CITY OF ST. LOUIS
**PLANNING & URBAN
 DESIGN AGENCY**
 CULTURAL RESOURCES OFFICE
 FRANCIS G. SLAY, Mayor

DATE: March 28, 2016
 ADDRESS: 230 N. Kingshighway Boulevard
 ITEM: Preliminary Review: Exterior alterations to 27th Floor Penthouse
 JURISDICTION: Central West End Certified Local Historic District — Ward 28
 STAFF: Jan Cameron, Cultural Resources Office

PARK PLAZA — 230 N. KINGSHIGHWAY

**CURRENT WEST ELEVATION SHOWING NORTH AND SOUTH ADDITIONS
AND PROJECTING ENCLOSURE BAYS**

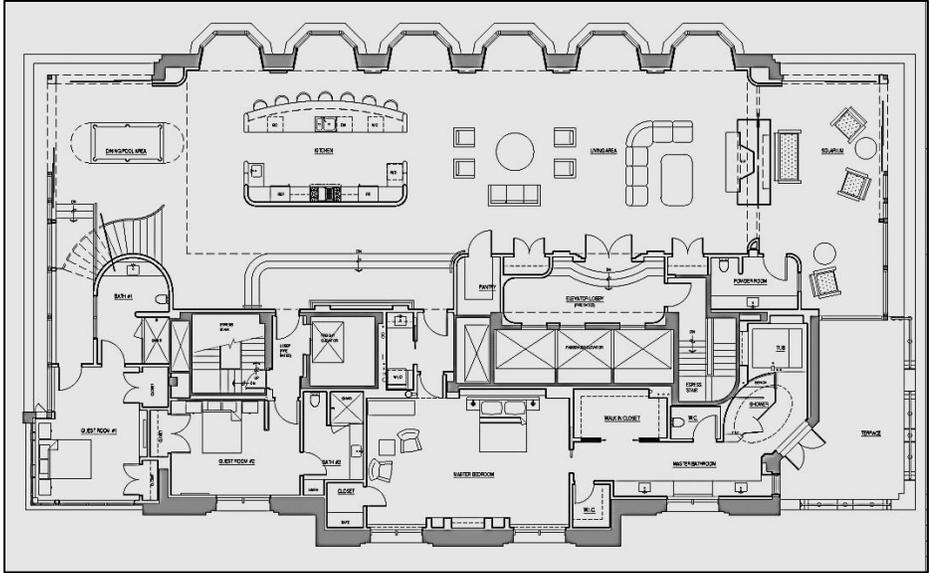
Partly complies. The project includes dismantling the six existing bay enclosures on the west façade that were added c. 1960. The deteriorated concrete sills will be repaired, the bays reglazed and then reassembled in the same configuration. To install the bays, the original window openings were altered in size and the projecting bases hollowed out to accommodate the bay structures. Therefore, it is not possible to return the openings to their original appearance.

- The north and south additions are inconsistent with the Park Plaza’s Art Deco design. Replacing the lower portions of the additions with a larger expanse of glass is acceptable, as the additions’ visual mass and their effect upon the building will be reduced.

- Supplemental railings to be mounted behind the decorative parapets will have little visual effect upon the building.
- The original openings of the west façade have been greatly altered and cannot be returned to their original condition.

Based on the Preliminary findings, the Cultural Resources Office recommends that the Preservation Board grant preliminary approval to the alterations proposed for the existing terrace additions and to the repair of the existing western window bays, but recommends the Board withhold approval for the alterations proposed for the Special Windows of the east façade, as that work is not in compliance with the Central West End Standards.

PROPOSED ALTERATIONS TO EAST WINDOWS

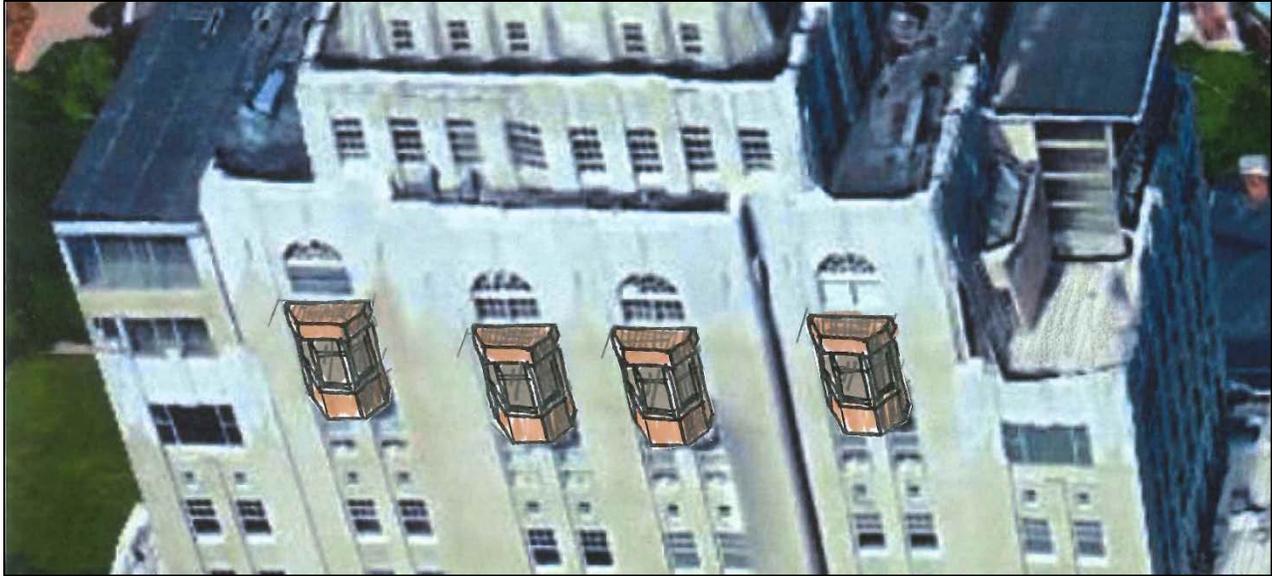
Does not comply. The project proposes to remove four decorative windows on the east elevation and to construct in their place narrow projecting glazed bays in similar form and materials to the six projecting bays on the west facade that were added c. 1960.

Does not comply. Four windows of the east façade will be removed, the openings altered and projecting window bays installed which are similar in design to the enclosures added to the west facade.

The large multi-light windows of the east elevation are considered to be Special Windows. While some sashes have been replaced, the openings retain their original configuration, including the decorative fanlights. On this façade (and the front as well) the decorative projections below the windows were not intended to be accessed as balconies and the original openings were glazed with paired multi-light doublehung windows.

- The four large decorative windows of the east elevation are Special Windows and therefore removal of the sash and the enclosure of the center openings is in violation to the Standards.

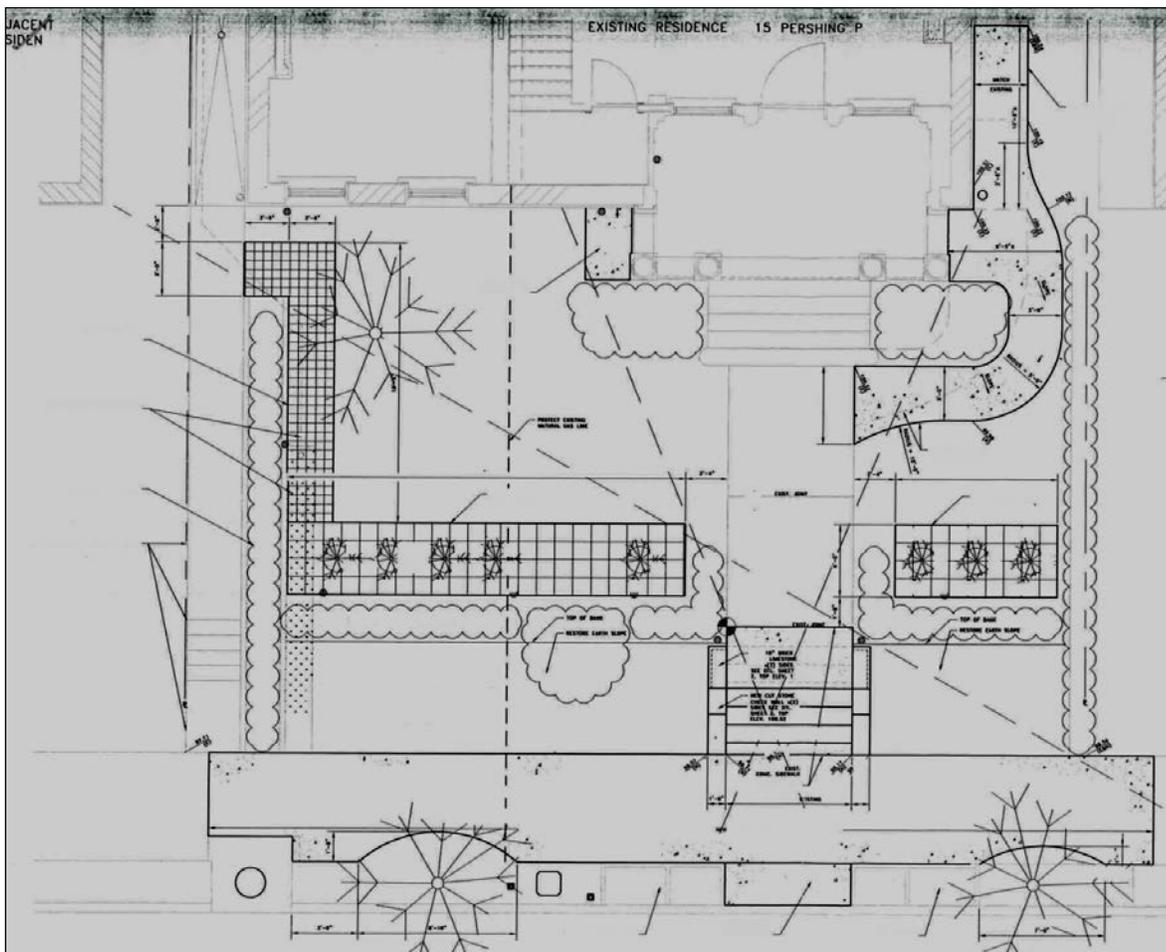
Does not comply. The repositioning of the steps would be an alteration of a feature that appears to be in the most logical location to accommodate the grade change in the on-premises sidewalk, and therefore historic. Maintaining the steps in their current location avoids the alteration of a character-defining feature of the historic front yard landscape.

The moving of the front steps and the construction of the two decorative knee walls introduces conjectural features onto the site. Adding conjectural features is discouraged as to not introduce elements that might appear to be historic, but were not original to the site, into the public portion of a property. The proposed knee walls, which have design elements drawn from the building, would be sited adjacent to the public sidewalk and will be highly visible.

Does not comply. The majority of the houses on the block do not have the front yards covered in part by pavers but are lawns or covered in other forms of plantings. The extent to which this paving would be visible from the street, once the landscaping plan is completed, is undetermined. But the introduction of extensive paving is not a predominant use.

Based on these preliminary findings, the Cultural Resources Office recommends that the Preservation Board uphold the Director’s denial of the application as it does not comply with the Central West End Local Historic District standards.

PROPOSED WALL SITE PLAN

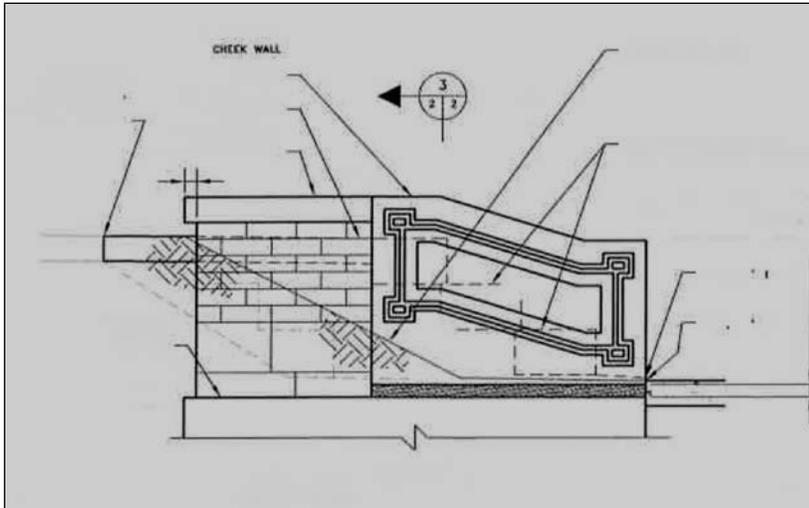
- 4615 Pershing Place is located in the Central West End Local Historic District.
- The standards do not allow for the alteration of historic features and the installation of new conjectural features like the decorative knee walls.
- The front steps are proposed to be moved forward from their original location in the historic slope in the yard to accommodate the new decorative knee walls.
- The standards state that, when there is a predominant ground cover, proposed new material should be compatible. The introduction of two types of pavers in addition to concrete walks, which would be over 124 square feet of the front yard does not meet the Standards.

INSTALLED WALL

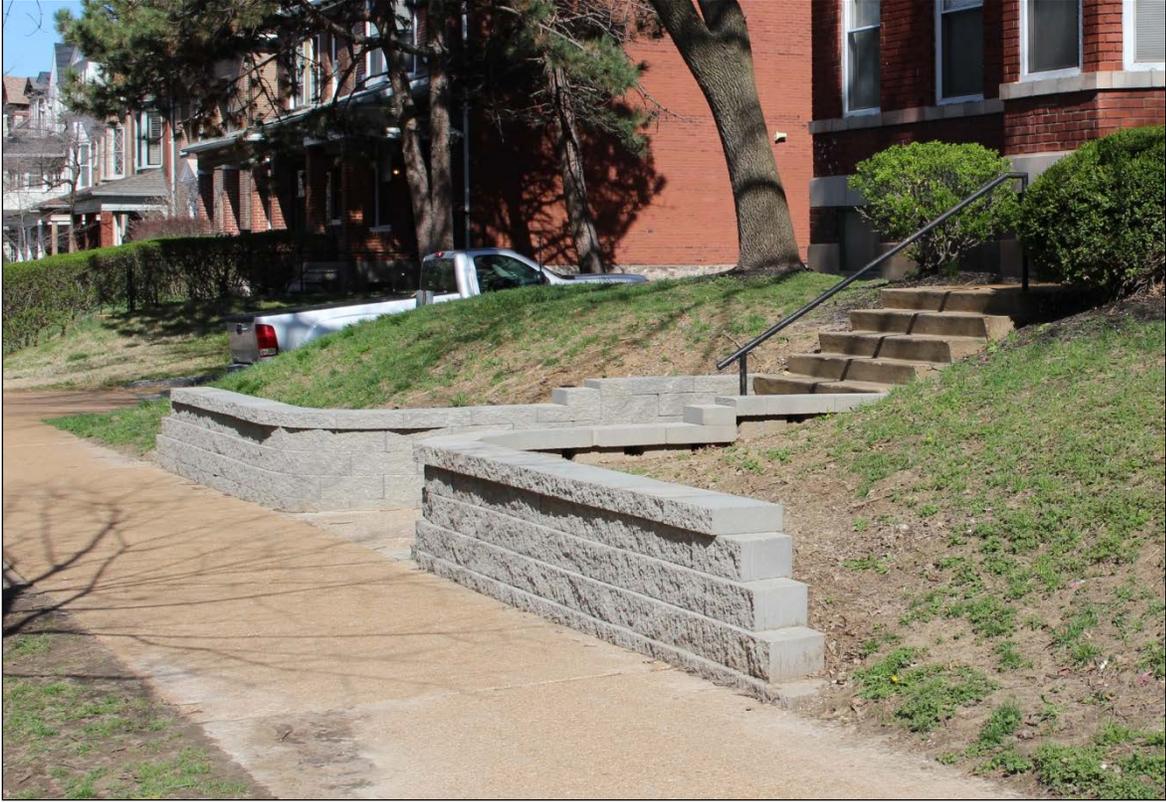
Does not comply. The original terrace has been altered and a new concrete block retaining wall has been installed. Both the new retaining walls and the material are prohibited under the standards.

- 4531 McPherson Avenue is located in the Central West End Local Historic District.
- The walls were installed without a permit.
- The slope of the front terrace has been altered.
- The walls are highly visible and constructed of decorative concrete block, which is not an acceptable material under the historic district standards.

Based on these preliminary findings, the Cultural Resources Office recommends that the Preservation Board uphold the Director's denial of the application as it does not comply with the Central West End Local Historic District standards.

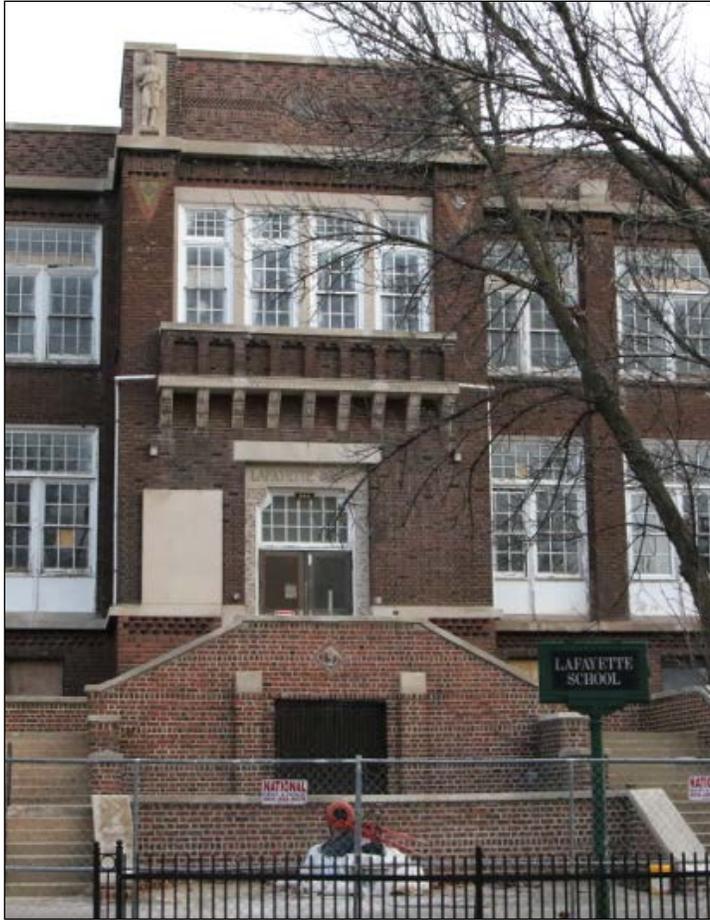
Although the gymnasium does not have openings on this elevation, it is designed to have three horizontal sections with brick color and patterning that break up the expanse of the wall. The new vehicular door is proposed to be centered on the front façade of the gymnasium, cutting through the stone band that serves to delineate the horizontal divisions of the façade.

Furthermore, the design of the new opening and its door are not comparable with the quality of the design and level of finish of the gymnasium, making it appear to be an ad-hoc change to the building. This is a component that could be considerably improved with some trim on the opening and a careful selection of the garage door.

Does not comply. A 6-foot aluminum fence would be installed at the sidewalk line on Ann from the east edge of the main school building to the 7th Street sidewalk, and along the sidewalk on 7th Street. Currently there is a 6-foot chain link fence along 7th Street, but the fencing along Ann in front of the main part of the school is a low fence that meets the standards. The portion of the tall fence in front of the narrow connector and gym would not meet this standard. Nevertheless, much of the taller fence would be enclosing a parking area, and such enclosure has become an acceptable means to provide security.

- The vehicular door installation on the Ann Avenue façade of the gymnasium addition would be a substantial alteration to character of the building. In addition, the design for the new opening is not in keeping with the design and level of finish of the gymnasium, and is a component that could be considerably improved.

Based on these preliminary findings, the Cultural Resources Office recommends that the Preservation Board consider some elements of the project, such as the proposed fence and chimney removal, to be justified by the building type and location; and that other elements that have more impact upon the property, such as the main windows, front masonry closure and garage door design, be denied; and that the Cultural Resources Office review and approve changes to bring these elements into compliance with the Standards.
